**ADDENDUM NO. 2**

DATE: January 31, 2024

PROJECT: Benton Washington Regional Public Water Authority
Phase 1A – Water Treatment Plant Improvements – High Service Pump Station
Rogers, ArkansasBID DATE: February 21, 2024 at 2:00PM

JOB NO:
2124
SHEET NO:
MP3

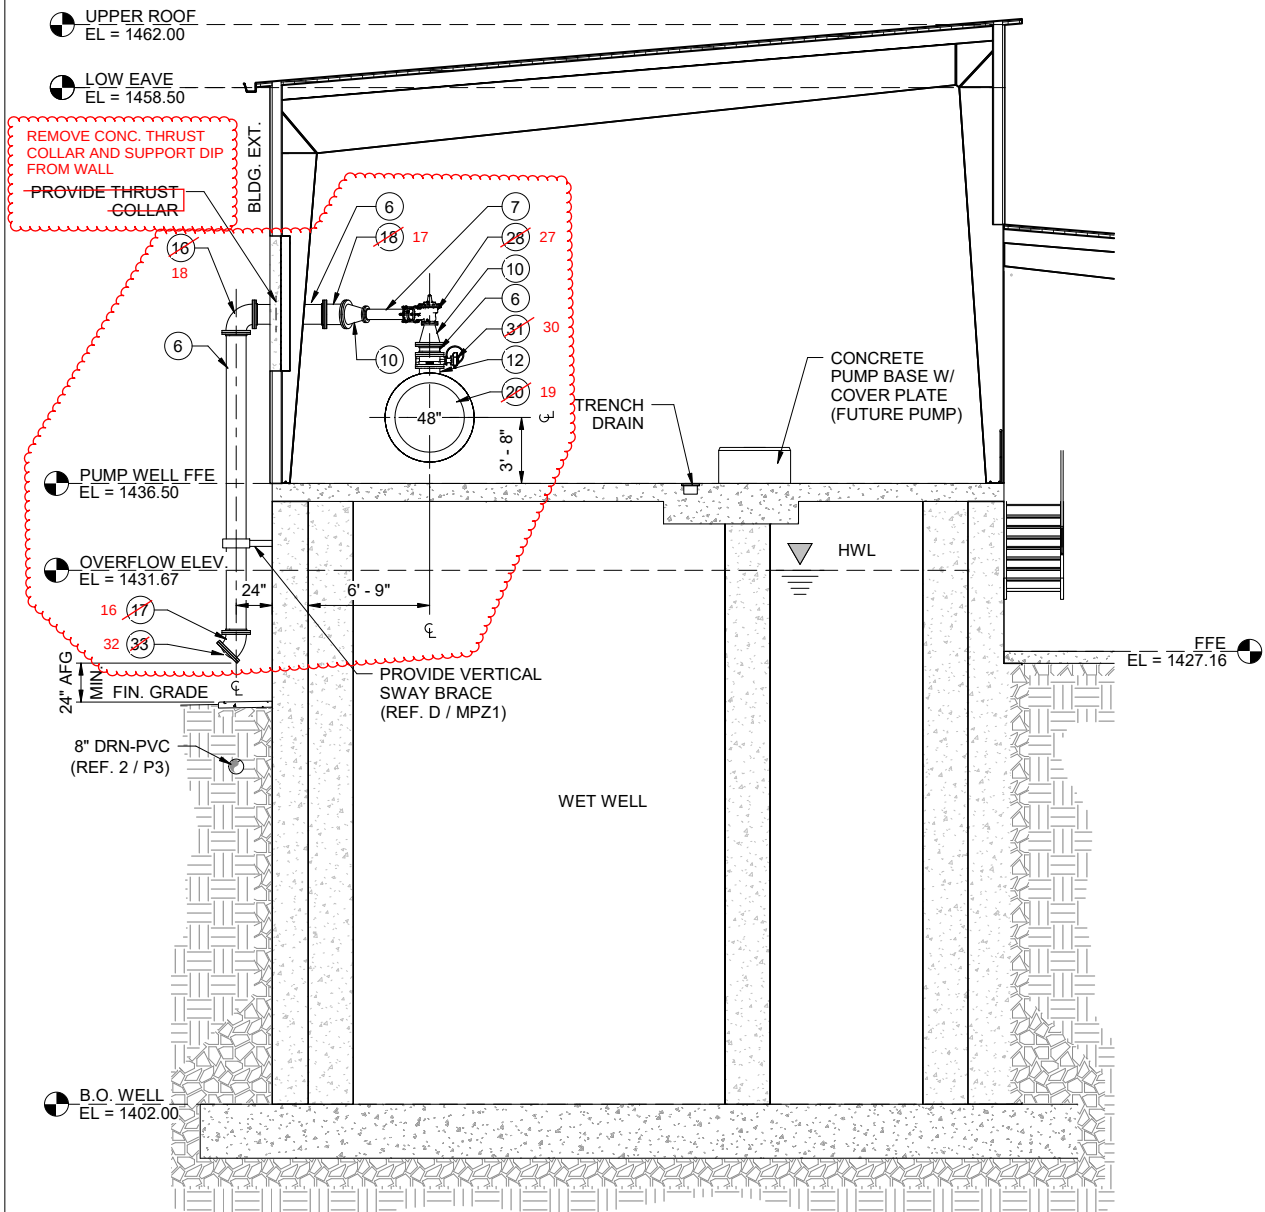
REV. NO.	DATE	DRWN	CHKD	REMARKS
1	1-31-24	CEI	JDM	ADDENDUM NO. 2, REVISED SCHEDULED EQUIPMENT MARKS

RODGERS, ARKANSAS
CAPITAL IMPROVEMENTS PLAN PHASE IA
WATER TREATMENT PLANT IMPROVEMENTS
CONSTRUCTION DOCUMENTS
HIGH SERVICE PUMP STATION
STORM & DRAIN PIPING RISER DIAGRAM AND SCHEDULE

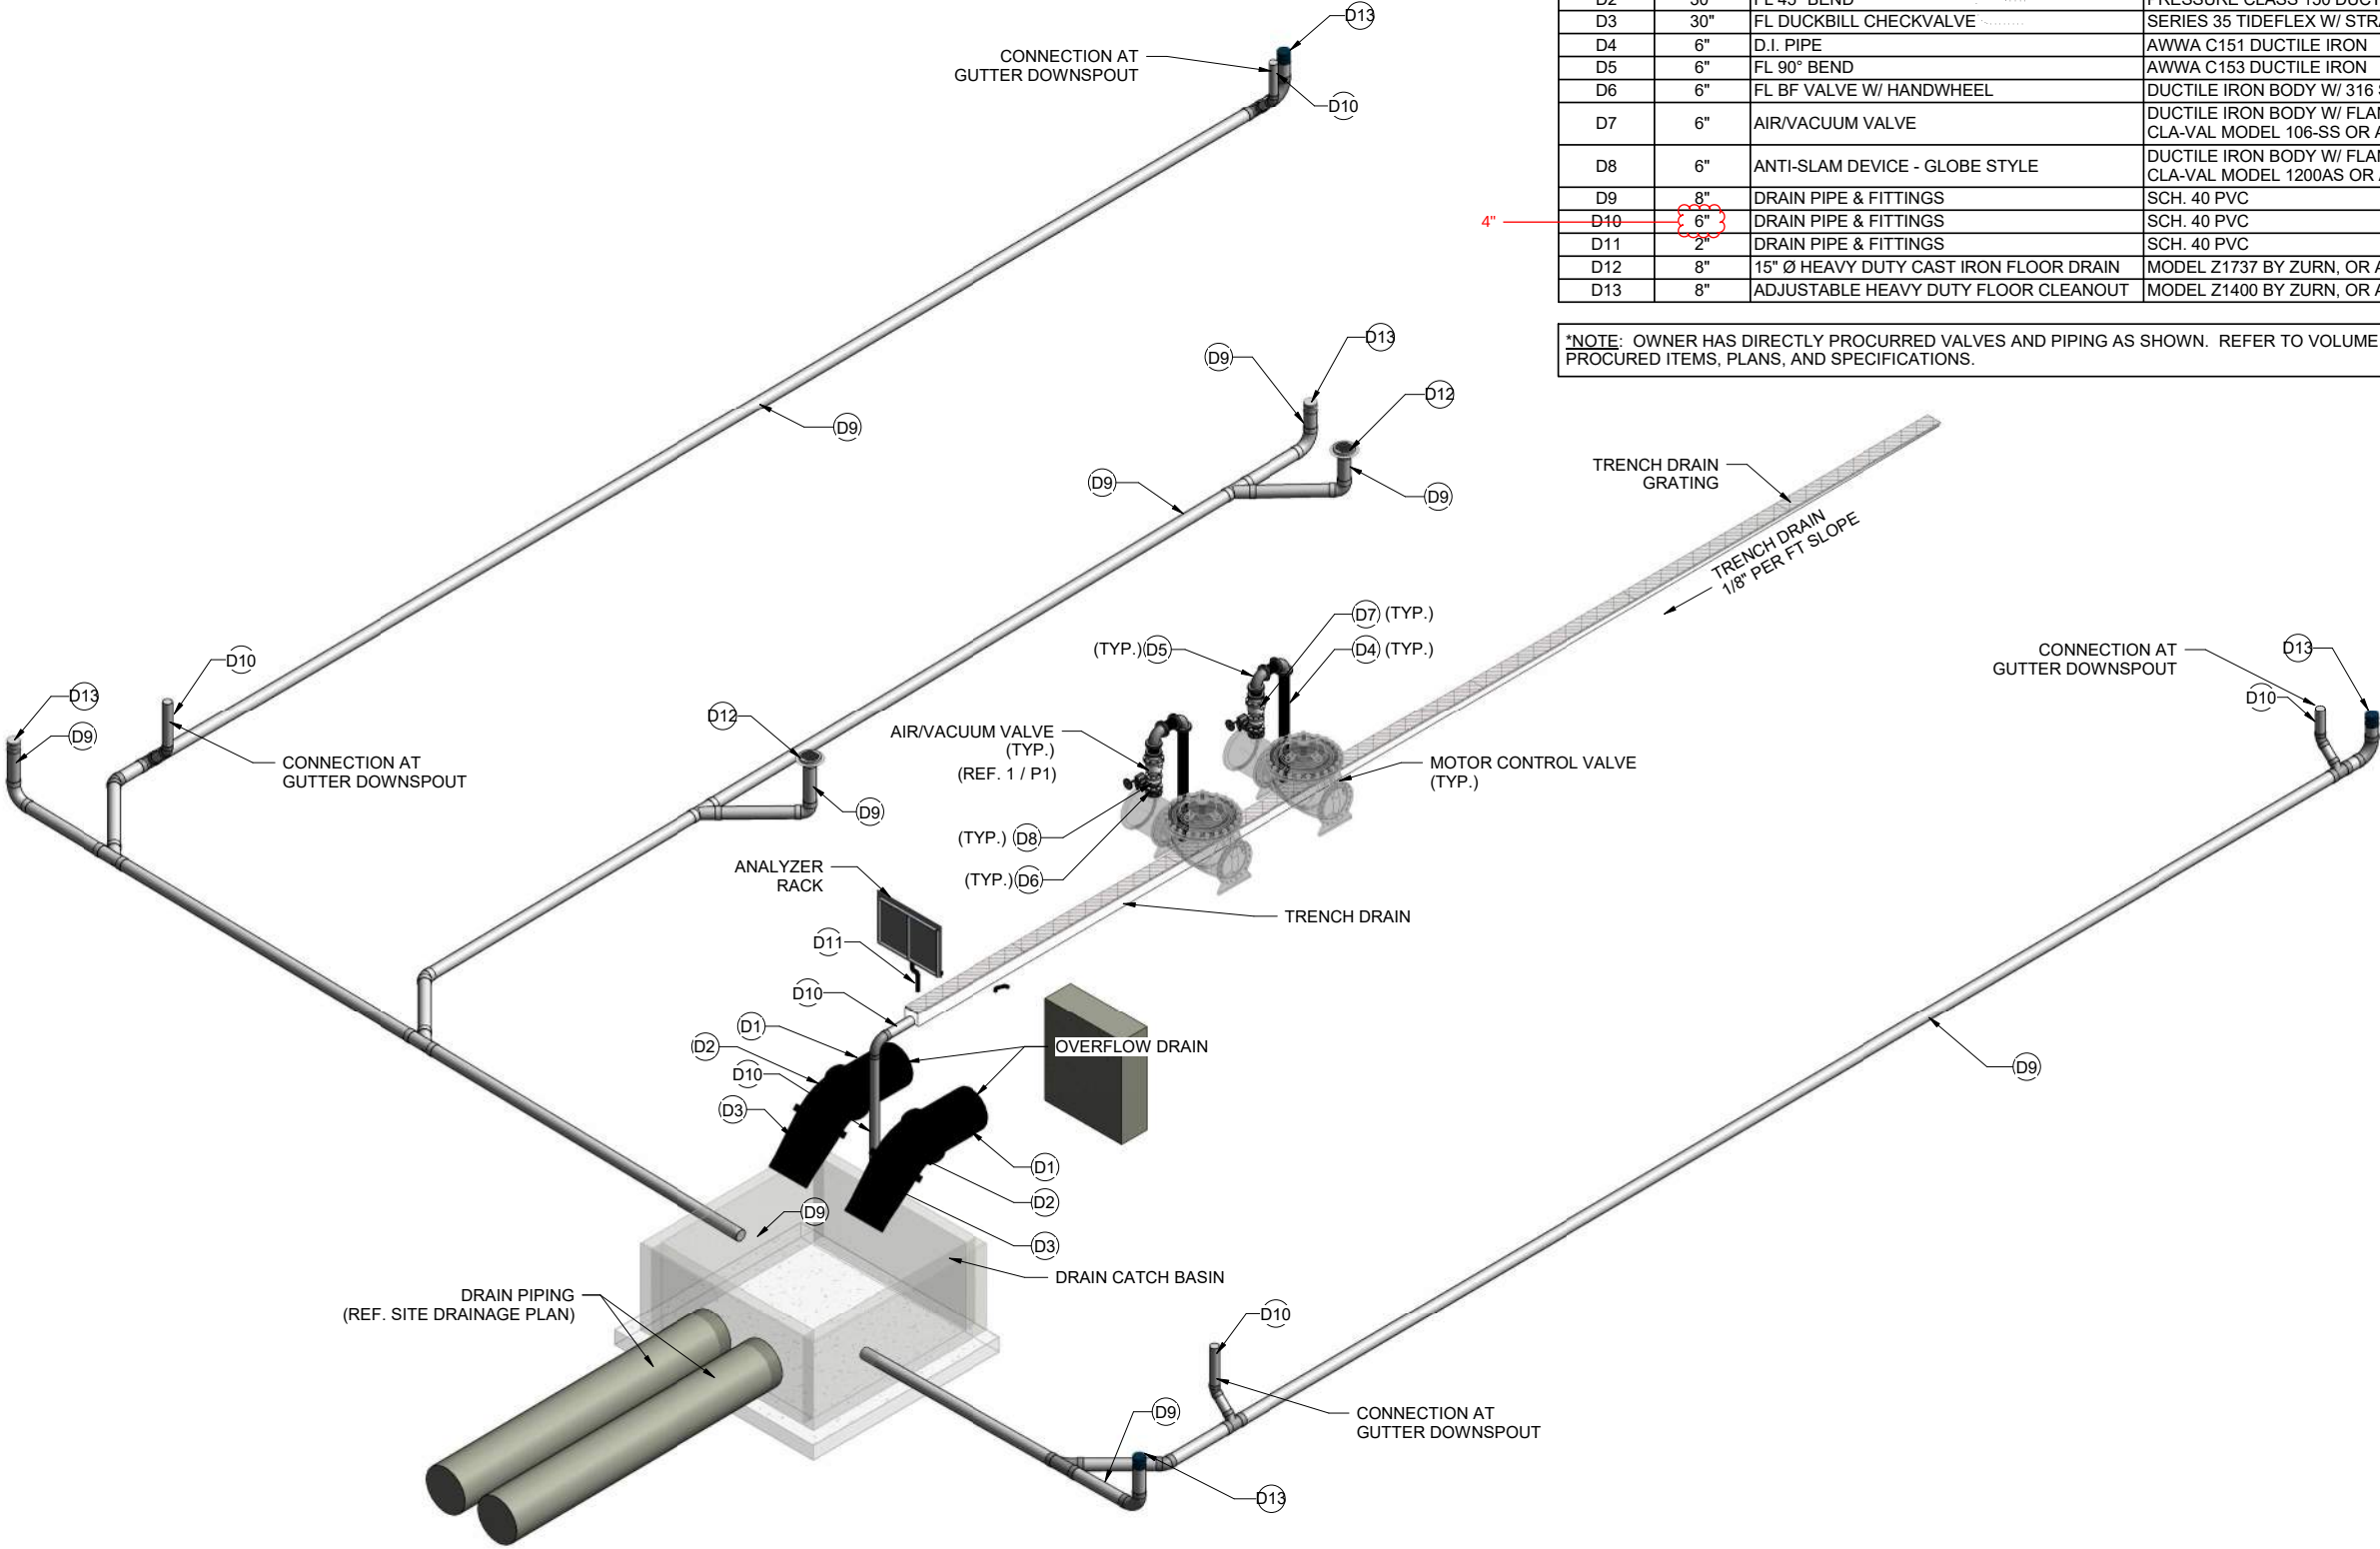
REV. NO.	DATE	DRWN	CHKD	REMARKS
1	1-31-24	CEI	JDM	ADDENDUM NO. 2, REVISED SCHEDULED PIPE SIZE
